Economic Commission for Europe**Inland Transport Committee****World Forum for Harmonization of Vehicle Regulations****Working Party on Pollution and Energy****Sixty-fifth session**

**Agricultural and forestry tractors, non-road mobile
machinery: UN Regulations Nos. 96 and 120****Proposal for 04 series of amendments to Regulation No. 96****Submitted by the expert from the European Commission***

The text reproduced below was prepared by the expert from the European Commission to align the provisions of UN Regulation No. 96 with the 8-mode cycle of European Directive 2010/26/EU and the 2012 amendment of European Directive 97/68/EC. This document is based on Informal document No. GRPE-64-03 distributed at the sixty-fourth session of the Working Party on Pollution and Energy (GRPE) (ECE/TRANS/WP.29/GRPE/64, para. 46).

"Figure 1

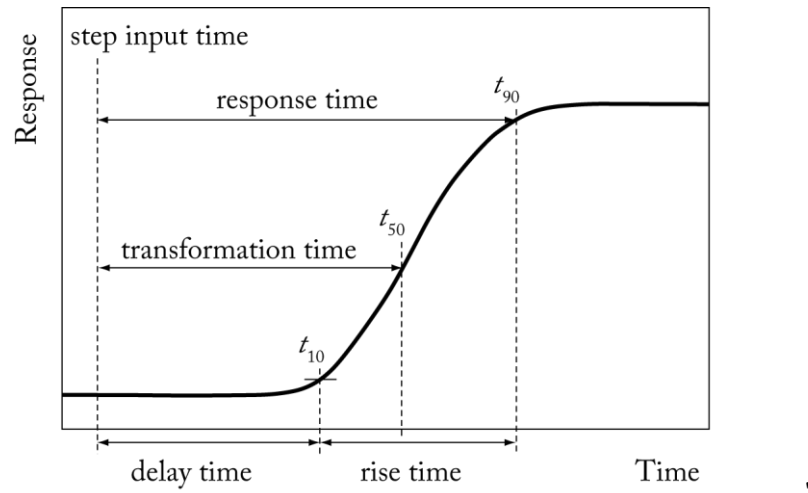
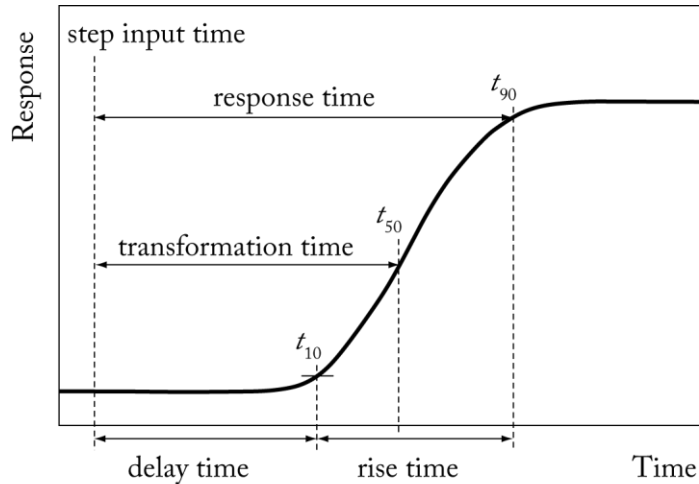
Figure 1, amend to read:

Definitions of system response: delay time (paragraph 2.1.1317.), response time (paragraph 2.1.5972.), rise time (paragraph 2.1.6073.) and transformation time (paragraph 2.1.7489.)

Figure 1.
Control area

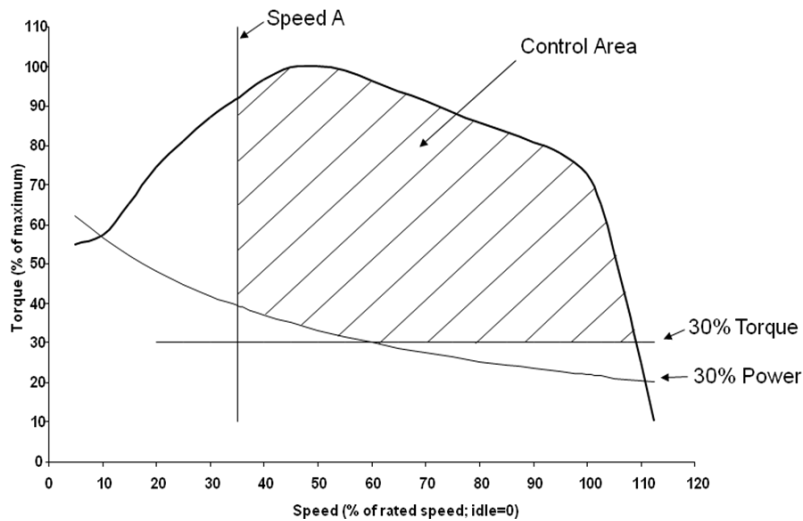
The control area (see Figure 1) is defined as follows:

speed range: speed A to high speed;

speed A = low speed + 15 per cent (high speed - low speed);

5.3.5.3.2. The following engine operating conditions shall be excluded from testing:

(a) points below 30 per cent of maximum torque;

(b) points below 30 per cent of maximum power.
